## **Remediation System Evaluation (RSE)**

**Alaric, Inc. Superfund Site**  
Tampa, Florida

Report of the Remediation System Evaluation  
Site Visit Conducted at the Alaric, Inc. Superfund Site  
April 29, 2009

Revised Report  
January 27, 2010

Title: **Cross-Section of the  
Primary Source Area  
Technical Memorandum  
Former Alaric Site, Tampa**

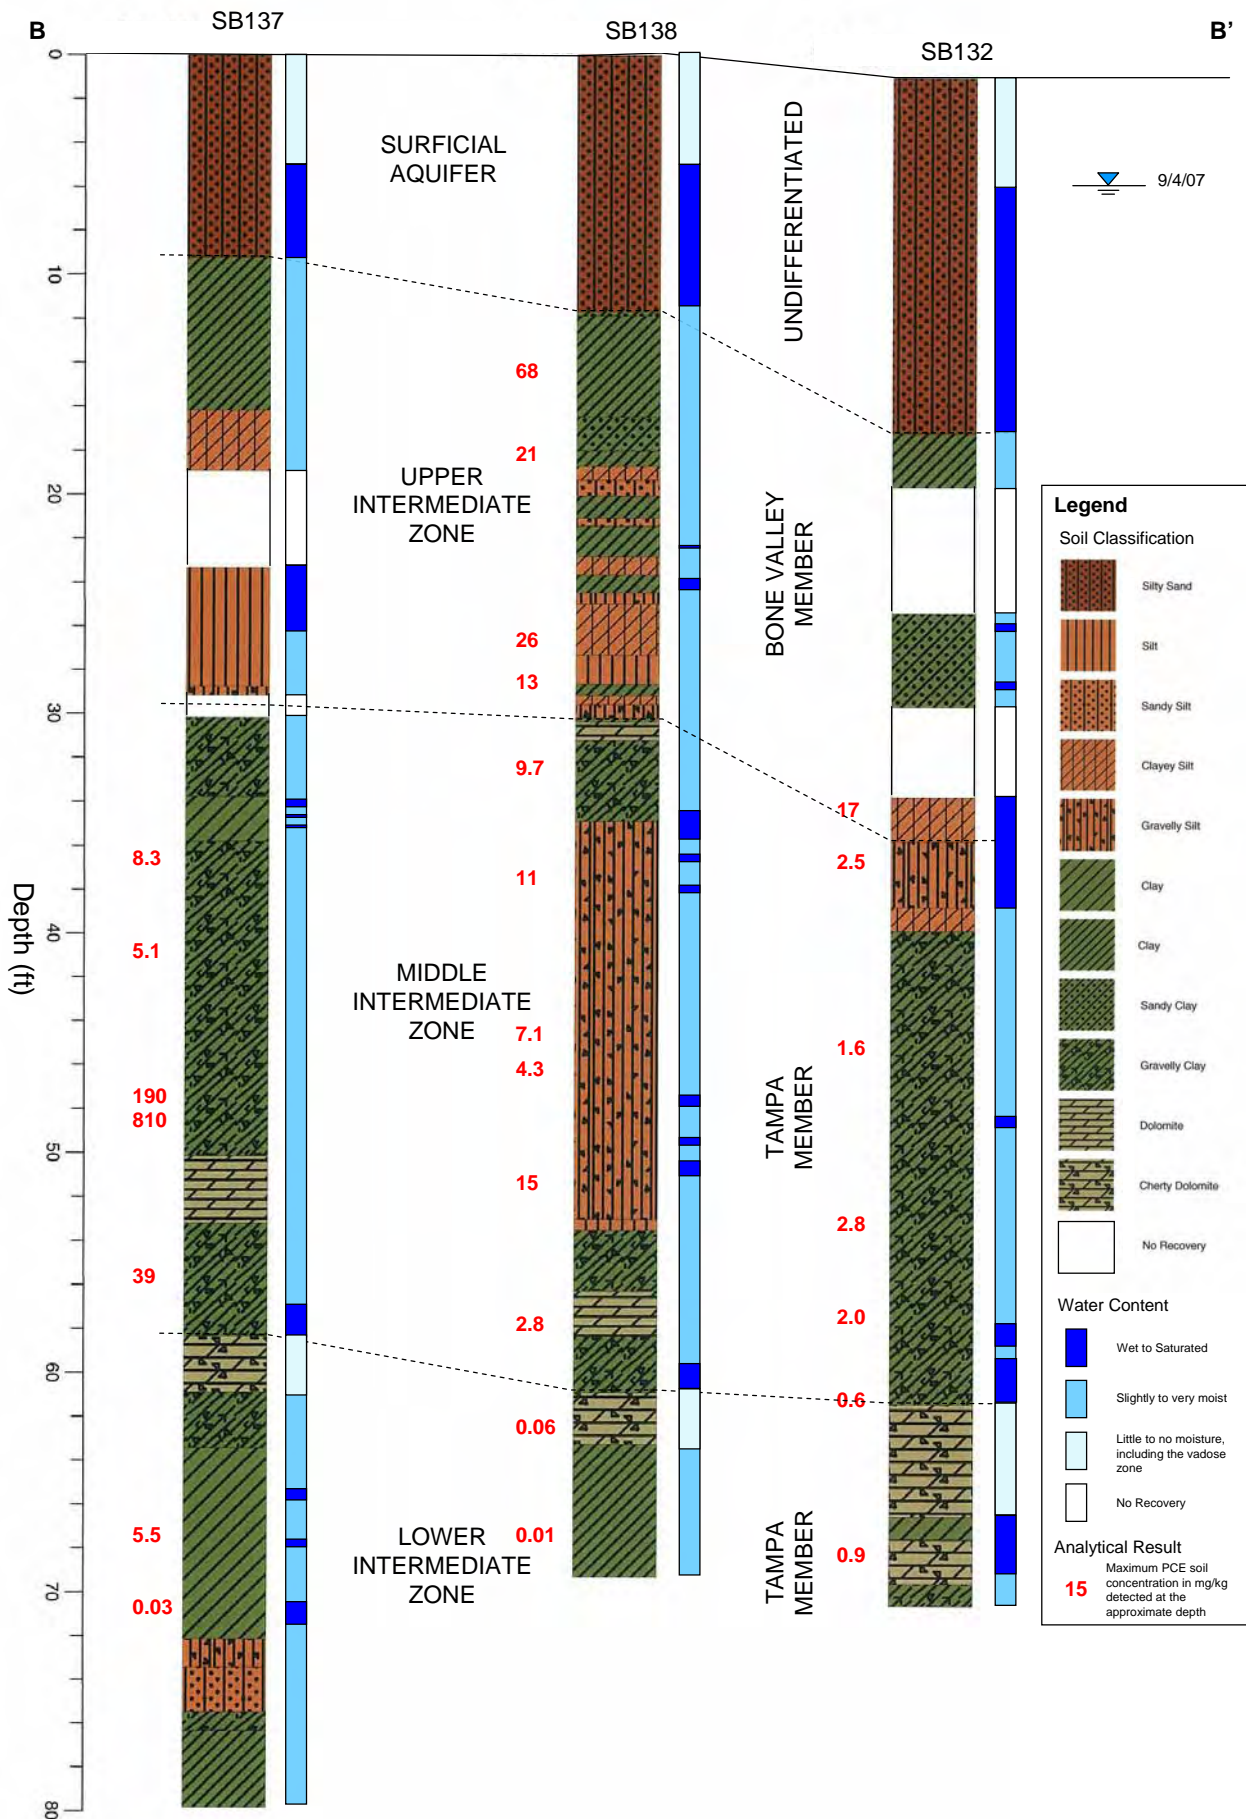
Figure 3-2 from the October 2008 Technical Memorandum (see Attachment A) provides an indication of Site stratigraphy, and the following table from the same document summarizes key hydrogeological information for the shallow zone (SA in the table) and the intervals of the IZ.

Figure K-18

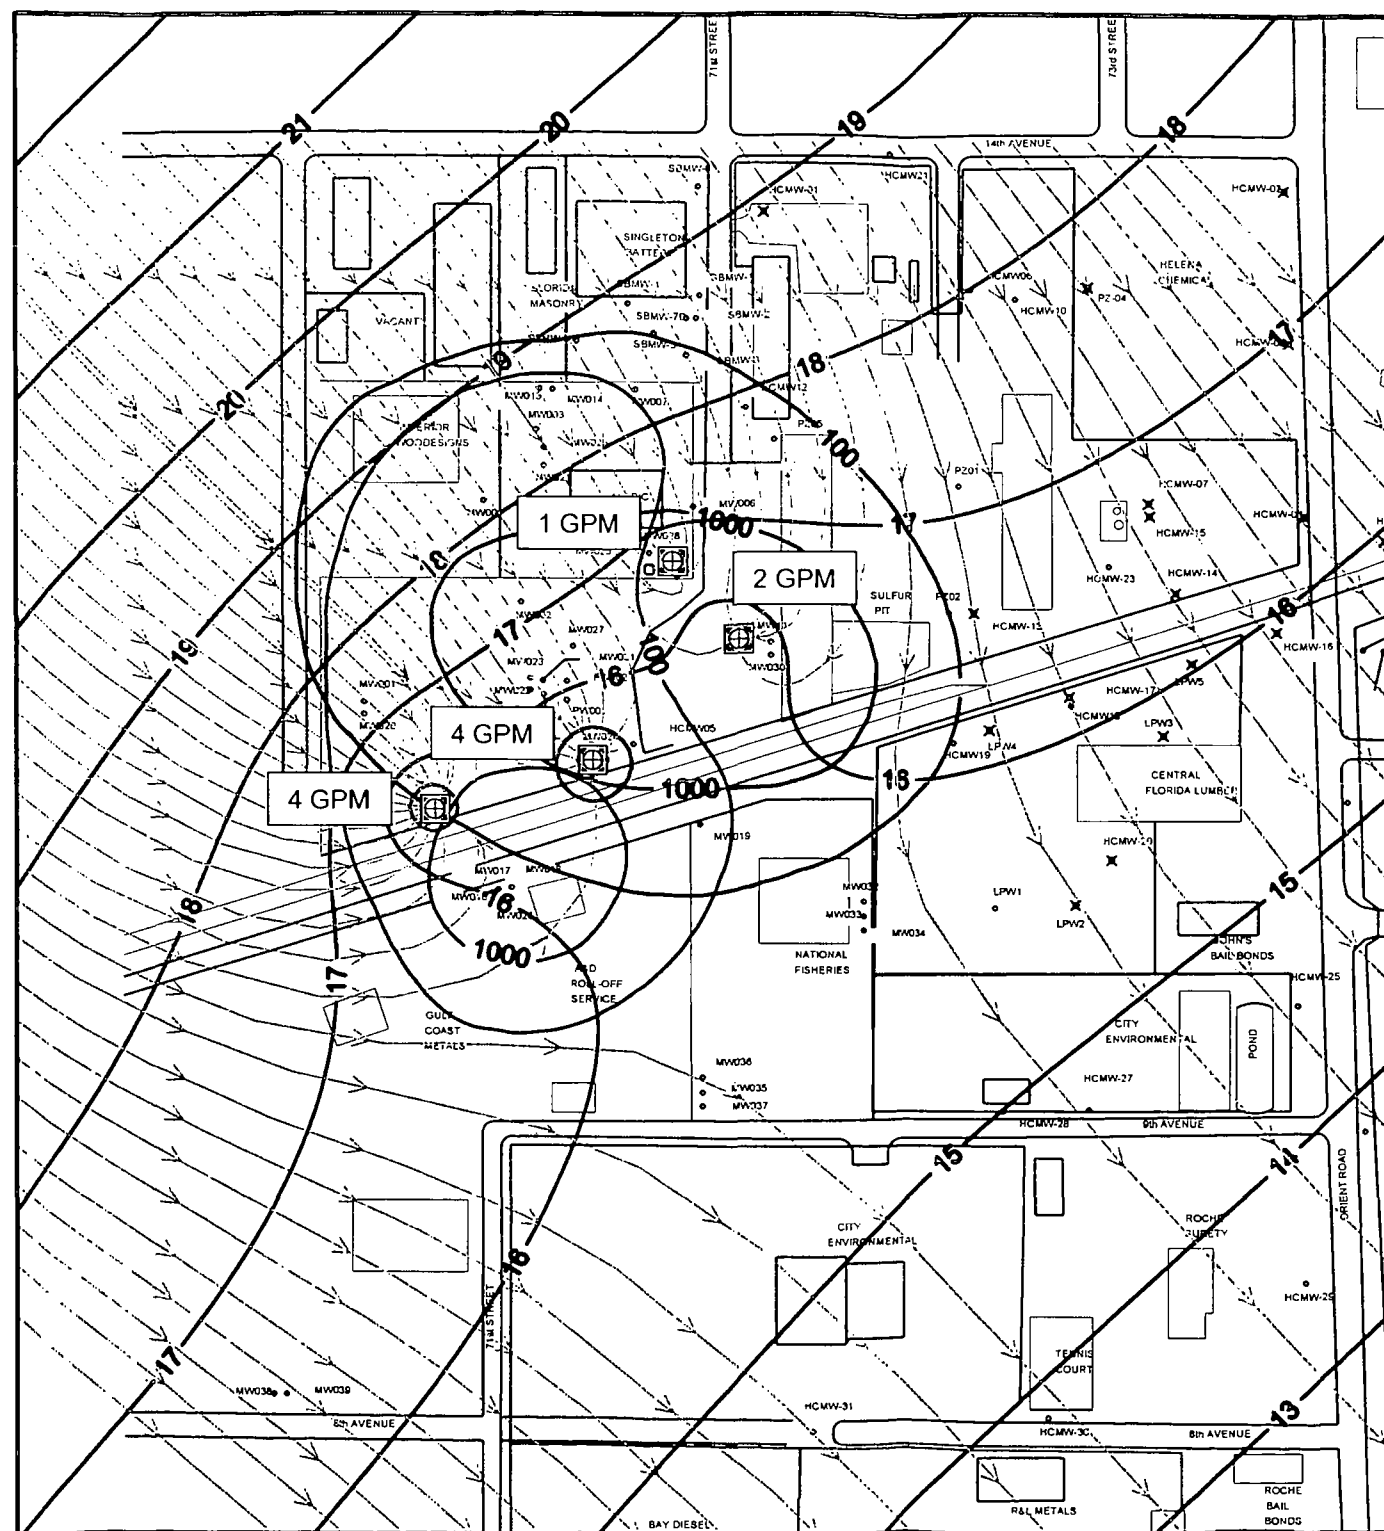
The design basis for the IZ system included ground water modeling that suggested 11 gpm would be required for plume capture. Figure K-18 from the Remedial Design (see Attachment A) suggests capture of the 1,000 ug/L plume but not necessarily complete capture of the 100 ug/L plume. A target capture zone was not specified, but given that the depicted pumping scenario was selected as the design basis, the illustrated degree of capture is apparently sufficient to meet objectives. The model calibration upon which this simulation was conducted is questionable for the IZ (referred to as the Floridan at the time of the Remedial Design). Figure K-7 from the Remedial Design (see Attachment A) plots the simulated heads against observed heads, and it is clear that the plot does not follow the intended 1:1 trend. Rather, the simulated heads are low relative to the observed heads, and simulated capture may not be accurate. Additional model development and calibration incorporating actual pumping scenarios from the recovery wells (such as comparing observed versus simulated drawdown) has not occurred since this initial effort conducted as part of the design basis.
